Wisconsin Department of Transportation

Proposal #24: 2565-07-70, WISC 2021442
Green Bay Rd, Village of Brown Deer
Teutonia Avenue Intersection
STH 57
Milwaukee County

2270-04-70, WISC 2021441
STH 57-Vil Brown Deer & City Mequon
Teutonia Avenue to Mequon Road
STH 57
Milwaukee & Ozaukee County

This is Addendum No. 01, which provides for the following:

Addendum No. 01
 ID 2270-04-70
 Revised Sheet 21
 September 1, 2021

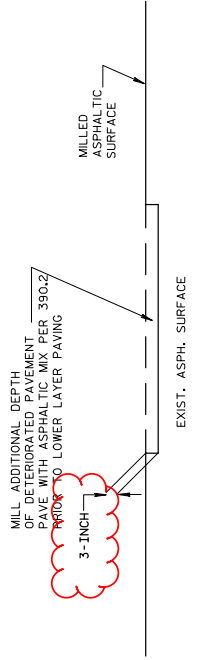
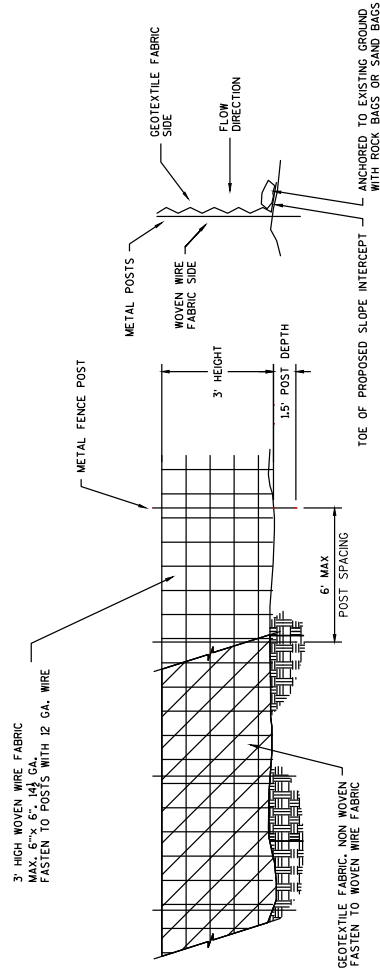
Revised Plan Sheets – 2270-04-70	
Plan Sheet	Plan Sheet Title (brief description of changes to sheet)
21	Construction Details (Revised milling depth to 3" on Base Patching Asphaltic detail)
167	Storm Sewer – Construction Details (Revised two general drainage notes related to backfill)
188	Sanitary Sewer (Removed force main work and associated notes)
190	Sanitary Sewer Manhole Detail (Revised structure 826.061 to remove force main relocation detail)
191	Construction Details (Removed inside drop detail)
756	Miscellaneous Quantities (Removed items related to sanitary sewer force main work)

BASE PATCHING ASPHALTIC
